[Docket No. FAA-2022-0891; Project Identifier AD-2022-00585-A,E,R; Amendment 39-22432; AD 2023-09-09]

Airworthiness Directives; Various Airplanes, Helicopters, and Engines

Final rule.

Figure A

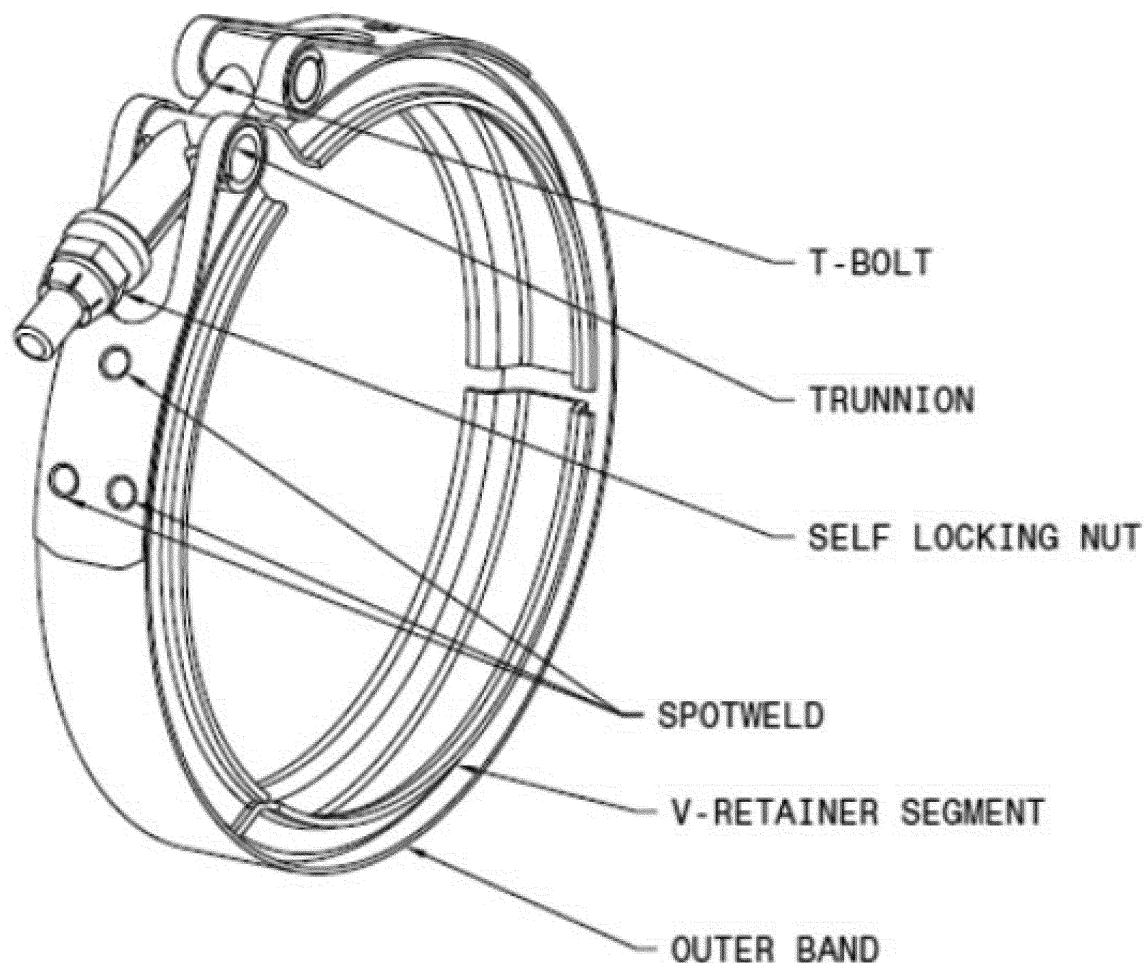
One individual commenter stated that instead of being spot-welded, the rings (v-band couplings) should be solid state welded. This commenter researched spot-welded couplings that revealed if the heat and pressure on the metal prior to the spot-weld is not consistent, the spot-weld will fail. Another individual commenter stated that spot-welds are good in tension and not in shear. The commenter further explained that as the v-band coupling is tightened, the spot-weld is in shear, and that adding dynamic loads reduces the spot-weld's life even further. This commenter suggested that a different type of attachment be used such as a braze joint or a laser weld.

An individual commenter stated that during manufacturing, the single spot-welds might be placed too close to the trunnions, thereby causing failure points. This commenter suggested using a total of four spot-welds instead of two spot-welds. The FAA infers that the commenter is requesting a change to the manufacturing of the v-band coupling.

The FAA has determined that inspections, in combination with life limits, are sufficient to mitigate the risk. The FAA would consider any future design improvements as an AMOC request following the procedures outlined in paragraph (n) of this AD. Regarding the proposed revision to AC 43.13-1B, that
